Nº 136 SERVICE BULLETIN

SUBJ: *Early Production* **PLAYBOY** *U7 Sound ROM Change*

Location of U7 Sound ROM
2/28/02 or later

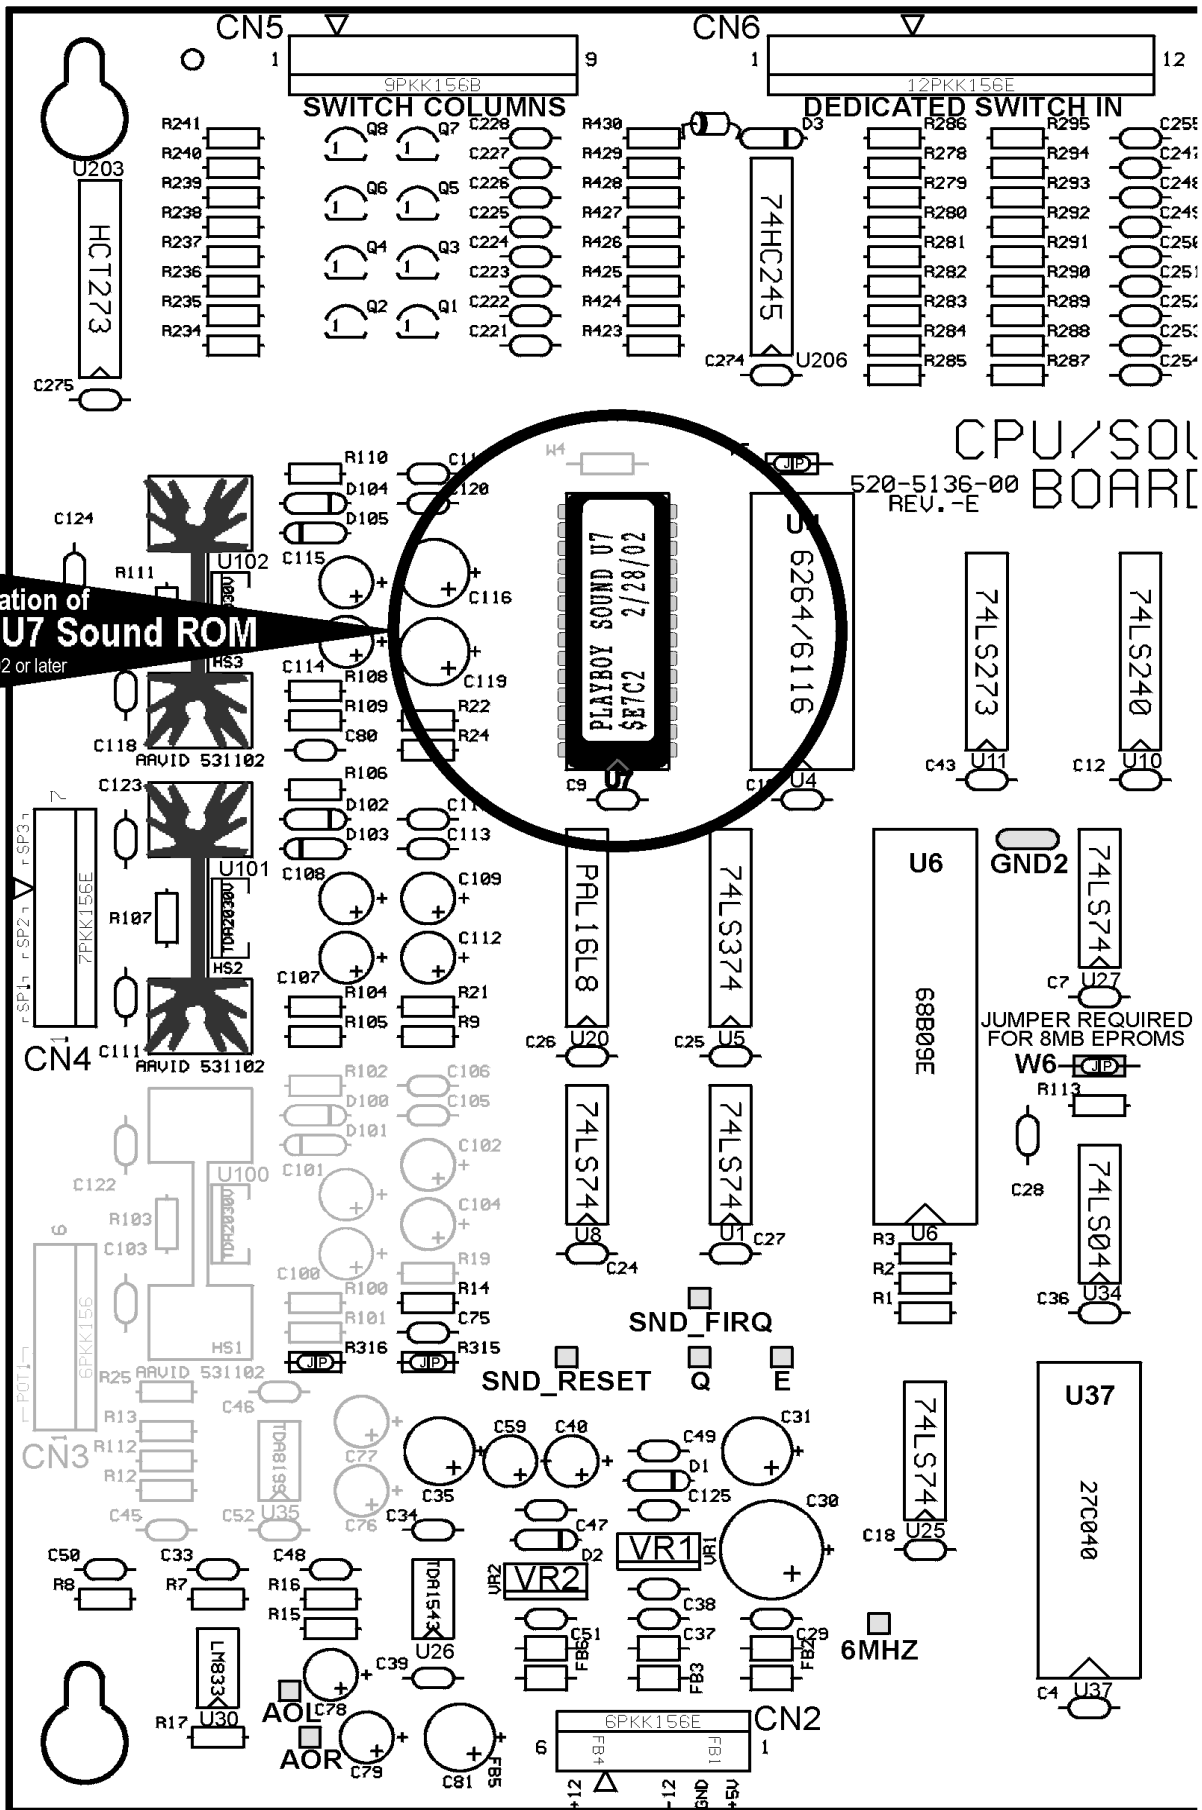
The above condition is caused by a *program bug* in early versions of the sound software. Check the date of your **U7 SOUND EPROM** on the CPU/Sound Board, any version *before 2/28/02* is subject to this problem. Any game prior to Serial Number 162626 should require this update (*double-check your CPU/Sound Board to ensure the EPROM wasn't already changed*).

View the following page ►► for the location of U7 on the CPU/Sound Board.

Replace your **U7 SOUND EPROM** with the latest version. If your Playboy Pinball has an earlier version of the Sound EPROM installed, you would also benefit from changing the **CPU GAME ROM** (*Loc: U210 directly under the Battery Back-Up Pack on the CPU/Sound Board*) and the **Display ROM** (*Loc: ROM 0 on the Display Controller Board behind the Dot Display*) to the most current production version.

Check Sum:
\$E7C2 for
U7 ROM
dated
2/28/02

JUMPER REQUIRED FOR 8MB EPROMS
W6
